This response to the Carpenters Road proposals 22/00256/A0D and 22/00249/NMA is from **Newham Cyclists**, the local borough group of the London Cycling Campaign (LCC). We represent the interests of people in Newham who already cycle, and campaign for safer streets that would make cycling a mainstream, inclusive, and convenient mode of transport for everyone.

SUMMARY

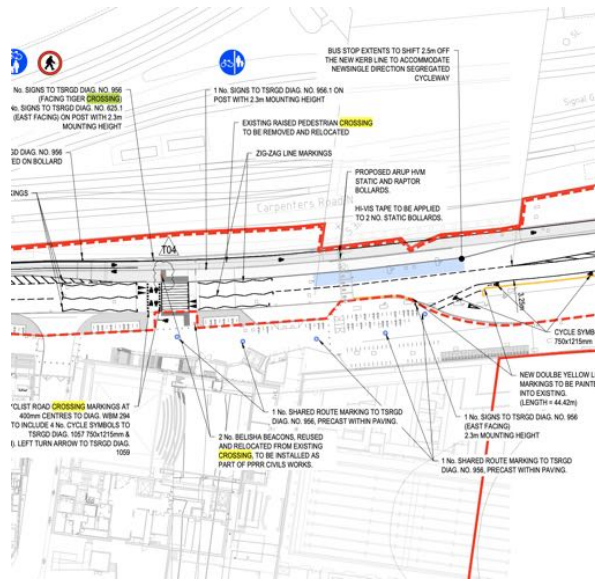
Where	Diagram	Our Comments
<p>Crossing and western end of cycle track</p>		<p>It is important that drivers are aware that people cycling will be crossing here and they need to give way. Signage (pursuant to TSGRD 950) would be appropriate.</p> <p>If traffic volumes are low and speeds are below the 20mph speed limit, the geometry of this junction is likely to be OK. If volumes increase, however—particularly if a reopened Carpenters Road becomes a preferred through route for drivers—and if those drivers regularly exceed the speed limits, it may need rethinking to be more generous with refuges and waiting areas for crossing pedestrians and cyclists.</p> <p>Pedestrians are likely to ignore ‘no pedestrians’ signs (and are entitled to do so since, in the UK, people are</p>

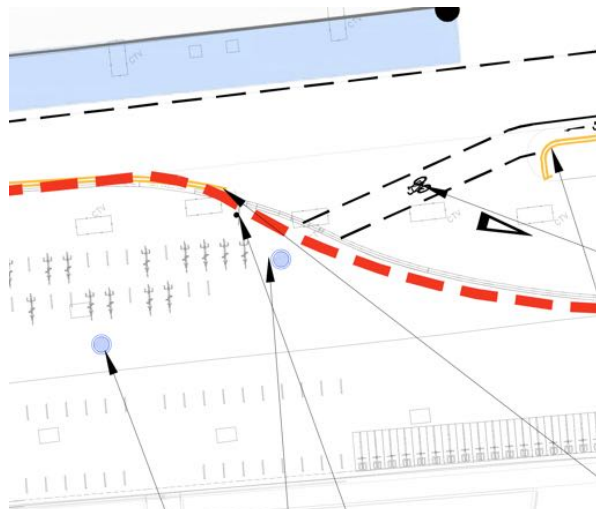
Where	Diagram	Our Comments
		<p>allowed to walk wherever on the road they like.)</p>
Centre line marking		<p>TfL have found that in some circumstances removing the centre line can help reduce traffic speeds as it has an optical narrowing effect.</p>
Cycle crossing to UAL LCF and V&A East		<p>Cycle symbols and give-way markings should be present in the refuge island to give people confidence in using the crossing correctly. TSGRD 950 signage may also be appropriate to warn drivers to expect people cycling.</p> <p>There must be a dropped kerb between the cycle track and the crossing. Dutch-style inritbanden/entrance kerbs (now available in the UK market) may be an</p>

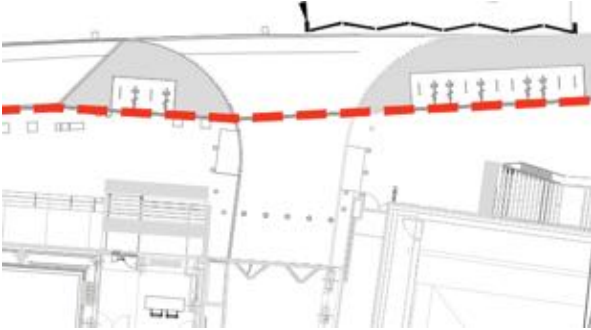
Where	Diagram	Our Comments
		<p>option to maximise the usable width of the carriageway and the cycleway. Another option, which might also help to reduce traffic speeds, would be to build the crossing on a raised table.</p> <p>As per LTN 1/20 paragraph 10.4.7¹ the refuge island must be at least 3m wide (in the direction of travel of the cyclist) to ensure everyone can safely use it.</p> <p>Overall the principle of this cycle crossing is good - however, there should be much more of them to allow people to access all the buildings from the cycle track.</p>
